Vehicle Owner Notification

Subject: VON #82 – Heater/Defroster 2 Fuse Replacement

VEHICLE OWNER NOTIFICATION #82

SUBJECT: HEATER / DEFROSTER FUSE REPLACEMENT

FIGURE 2

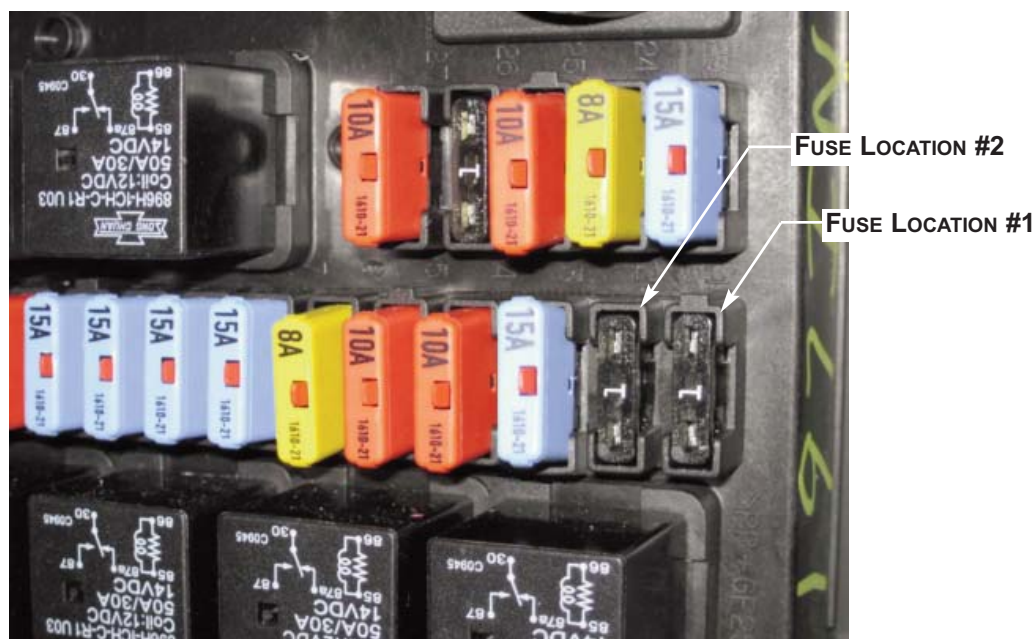
4. Locate the fuse or circuit breaker in locations #1 and 2 on PC Board #1 and replace it with a 1 amp fuse - TBB 151450. **FIGURE 2**

<u>PART NUMBER</u>	<u>QTY.</u>	<u>DESCRIPTION</u>
TBB 151450	2	1 AMP ATC FUSE
